**PLANNING COMMISSION AGENDA**  
**Monday, October 26, 2020 at 6:00 p.m.**  
**Caledonia Village Hall – 5043 Chester Lane**

- 6. Non-Public Hearing Items**
  - A. COOPERATIVE BOUNDARY AGREEMENT REVIEW – Consider a request to construct and utilize an 1,800 square-foot commercial building and parking lot located at 3500 Fourteen Point Lane, Daniel Oakes, Applicant, Top Flight LLC, Owner. (Parcel ID No. 168-04-21-25-004-000)

## PLAN COMMISSION REPORT

**PLAN COMMISSION REPORT**

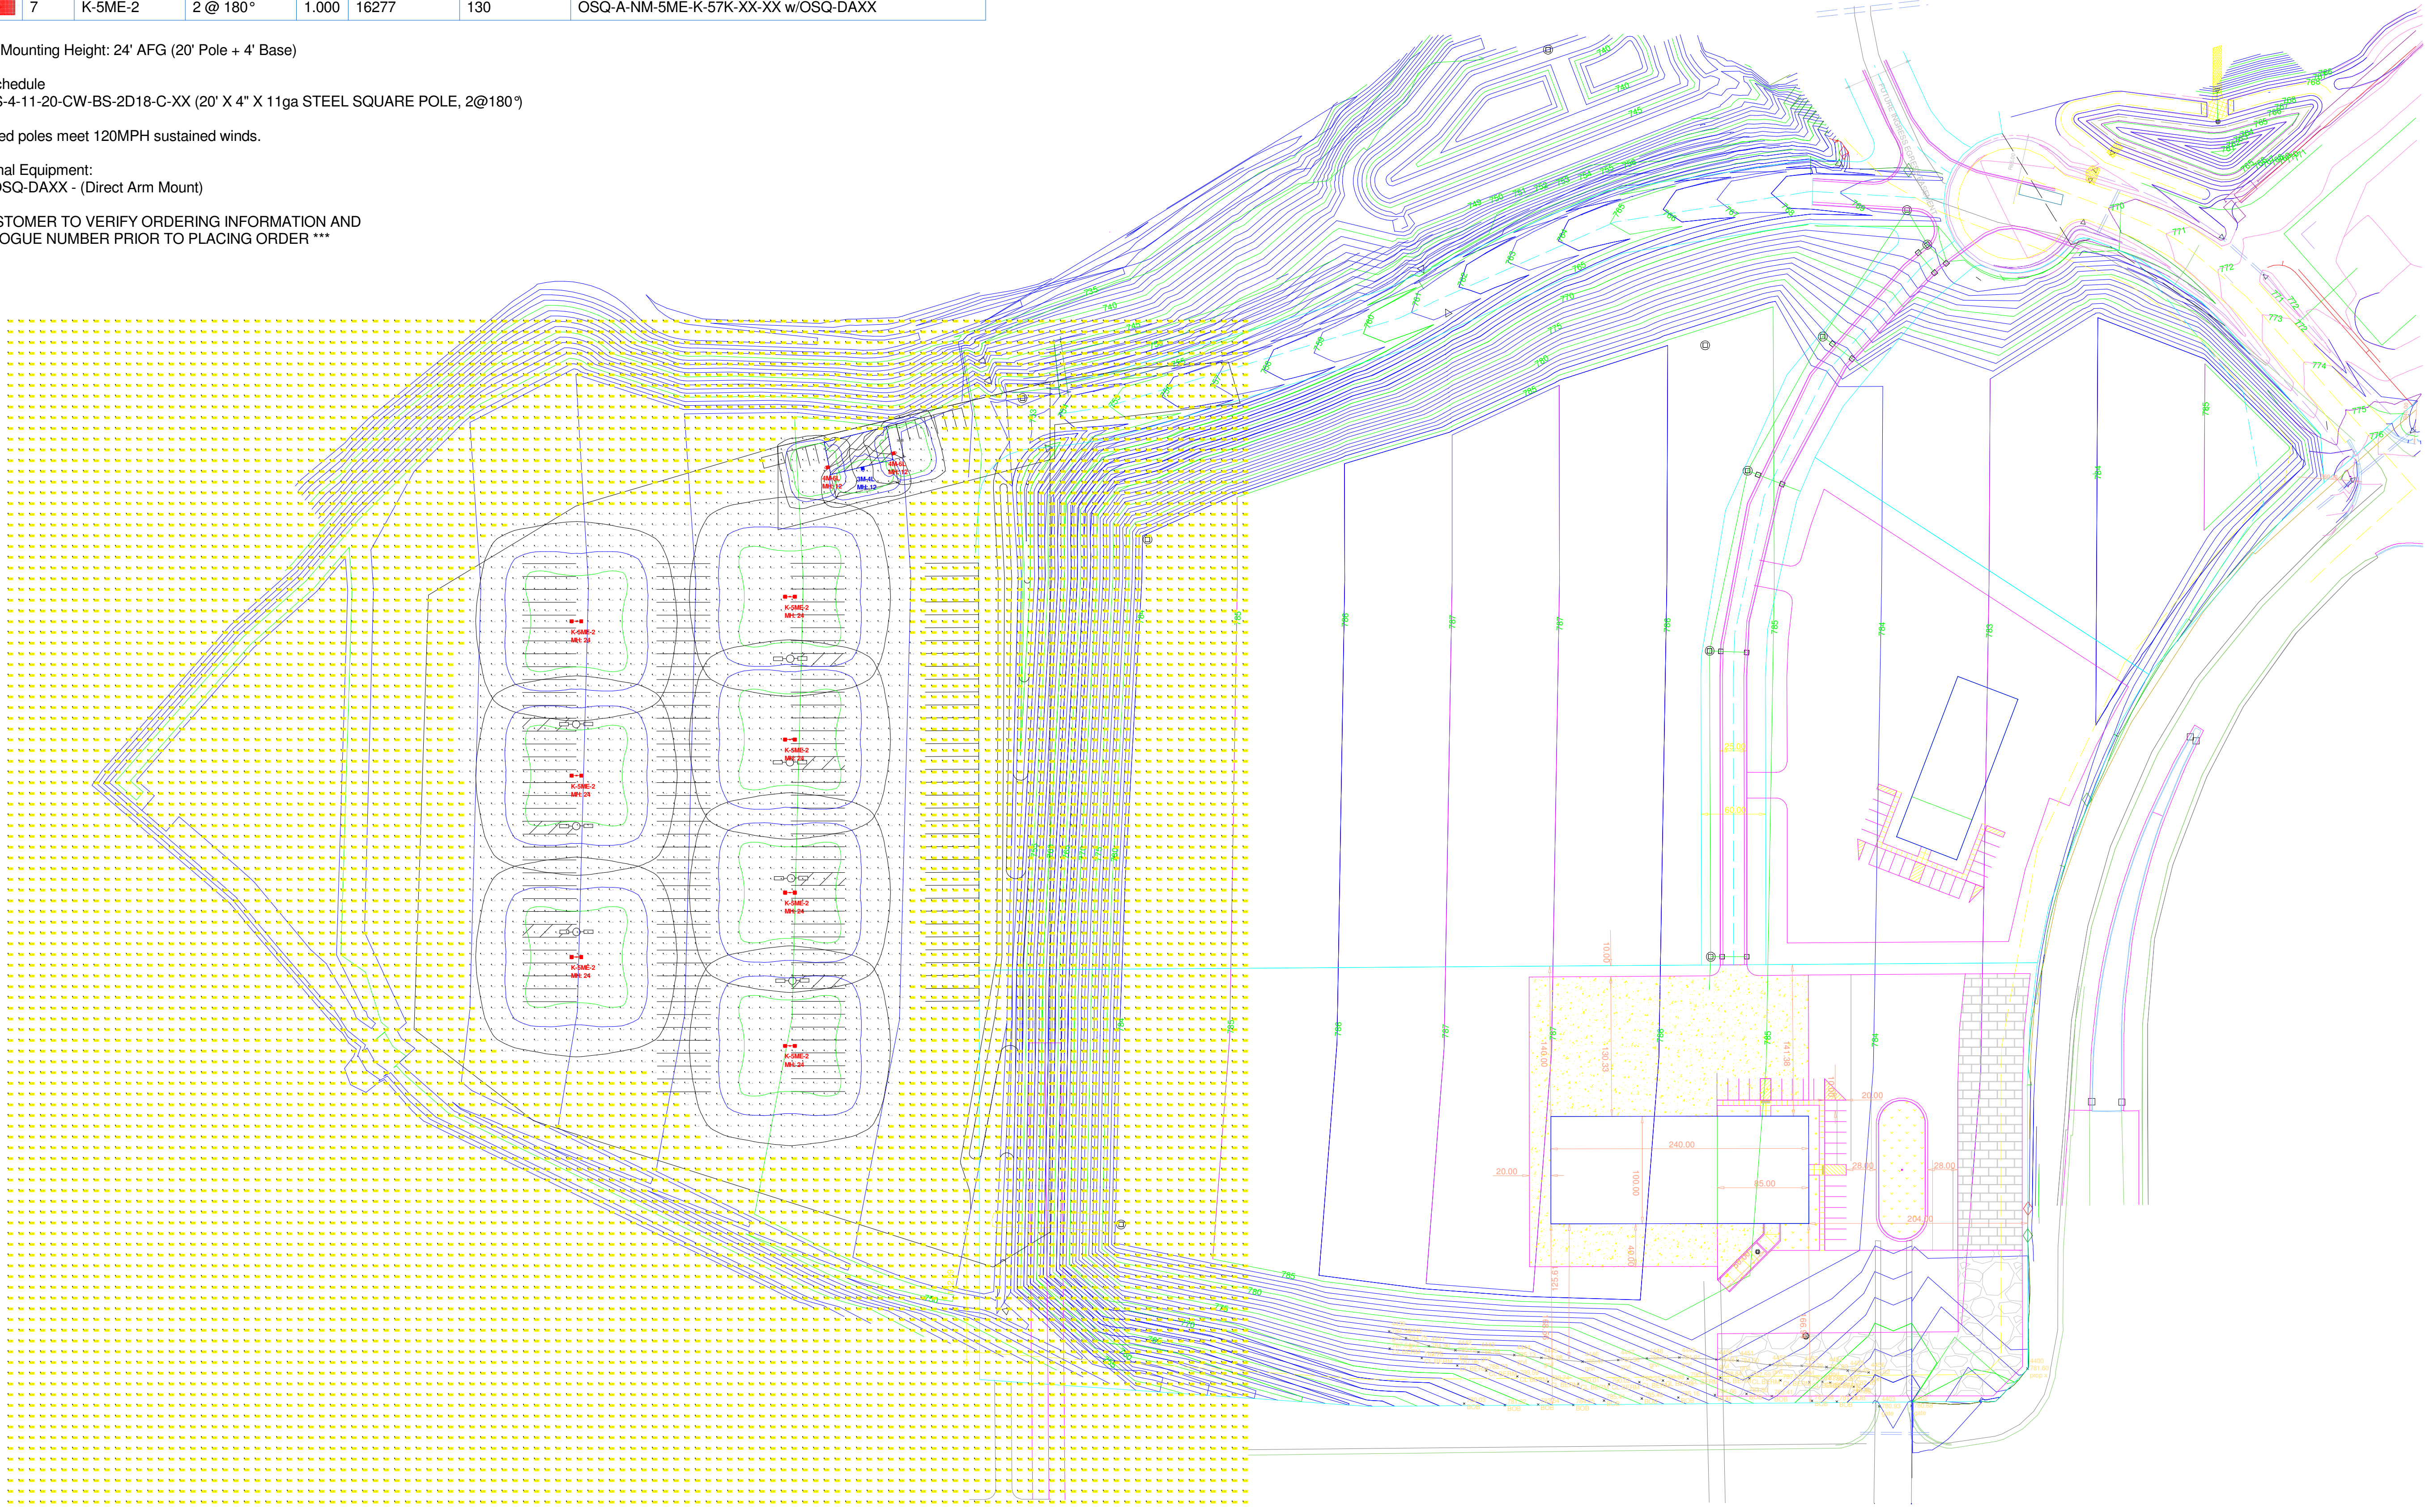
- a. The submitted lighting plan is in compliance with the 0.5 foot-candle requirement and have fixtures that are down-cast, cutoff fixtures. The proposed pole lights will be 20 feet in height atop a four-foot base which exceeds the twenty-foot height limit. However, the Plan Commission has the discretion to allow for taller poles if determined to be beneficial such as reducing the number of light poles to illuminate the same area.

WEST ELEVATION  
SCALE: NTS

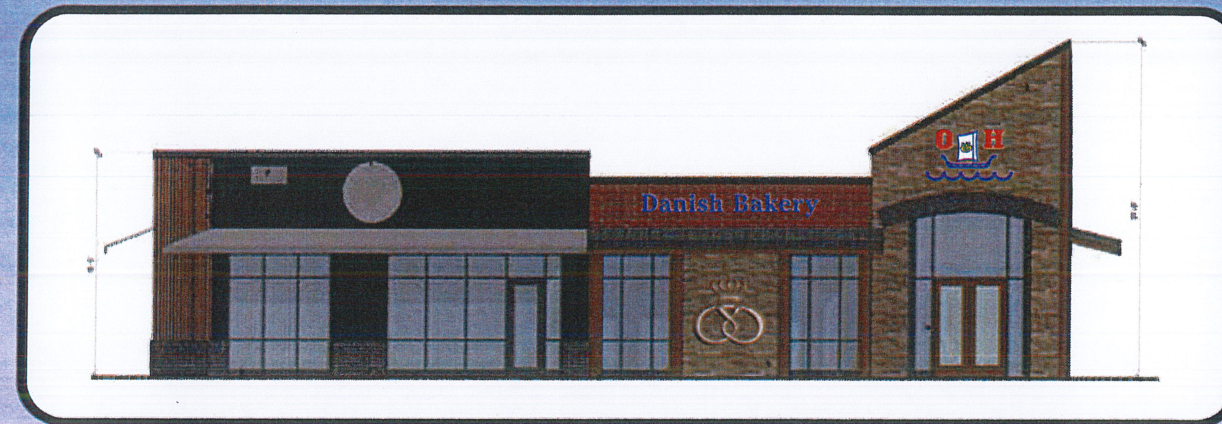
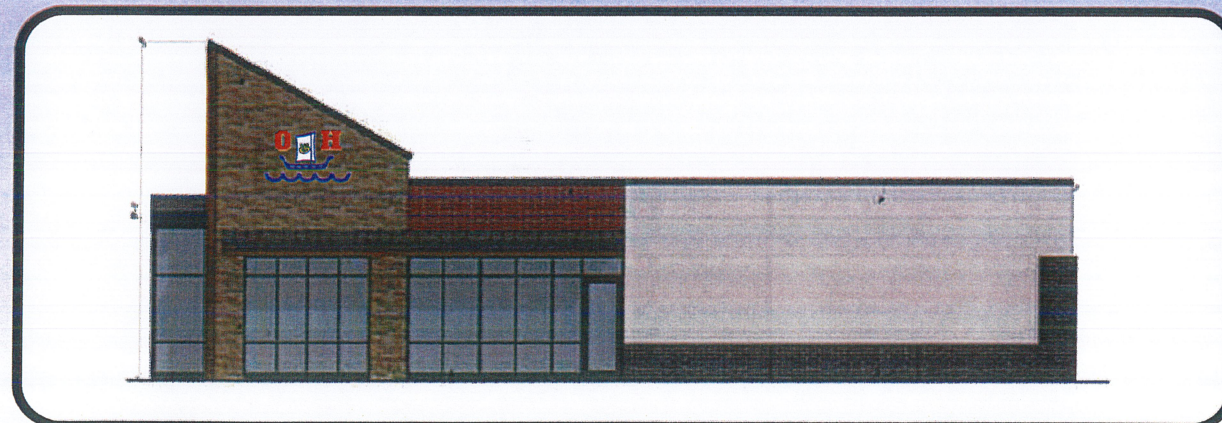
The proposed sign plan only has details for the southernmost tenant. The other tenant did not have specifics, but six sign placeholders were illustrated on the elevation drawings. O&H Bakery would like to install a total of four wall signs in its tenant space. All four signs comply with size and design codes. A monument sign is proposed for this site, but no specifics were submitted. Overall, the applicant is requesting a total of nine wall signs and one monument sign. Although the square footage of the other tenant is unknown, staff has calculated that if all proposed signs were designed at the largest permissible size, the total square footage of all signs would not exceed 1,200 square feet.

The proposed sign plan intends to maximize the visibility of the businesses by increasing the number of permitted wall signs. It is common for corner tenants to utilize both facades for signage purposes. Staff has some concern regarding the proposed south elevation wall sign as it faces a residential dwelling. However, the distance between the building and residential dwelling is approximately 100 feet or more and will have vegetative screening at the lot line to reduce the visual impact of the development and any glare from the sign.
